Rezoning Transportation Analysis

Petition Number: 2020-099

General Location Identifier: 04705303

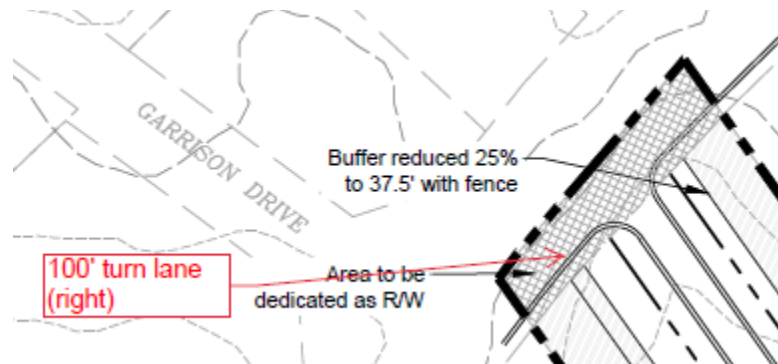
- a. **Technical Clarification (site plan dated 09/14/20)** The petitioner should clarify whether front-loaded or rear-loaded units are proposed. If front-loaded, the petitioner should commit to pair shared driveway aprons with every two units, to preserve the proposed planting strip and sidewalk within the public right of way. This request limits the number of curb cuts, promotes walkability, and preserves a quality streetscape.

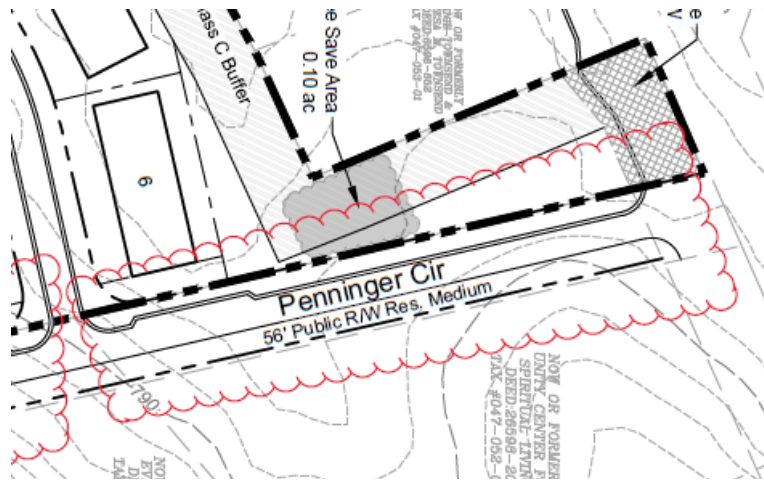
~~9. The petitioner should remove the proposed access on Mallard Creek Road, as shown below; NCDOT does not support an access at this location of Mallard Creek Road, in reference to the STIP's u-turn bulb-out. Please revise the site plan to provide adequate access for the existing single-family properties, using the proposed USDG Residential Medium/Wide section as proposed below. Please include sidewalk and planting strip on both sides of Penninger Circle.~~

- a. **Technical Clarification (site plan dated 09/14/20)** The petitioner should clarify the site plan to show and call-out the existing Penninger Circle private drive that ties into existing Mallard Creek Road. CDOT requests the petitioner to clarify that the existing Penninger Circle road improvements will be constructed in accordance with *CLDSMU-02 - Local Residential Medium Section* cross section design standards, on both sides of the existing Penninger Circle road centerline.
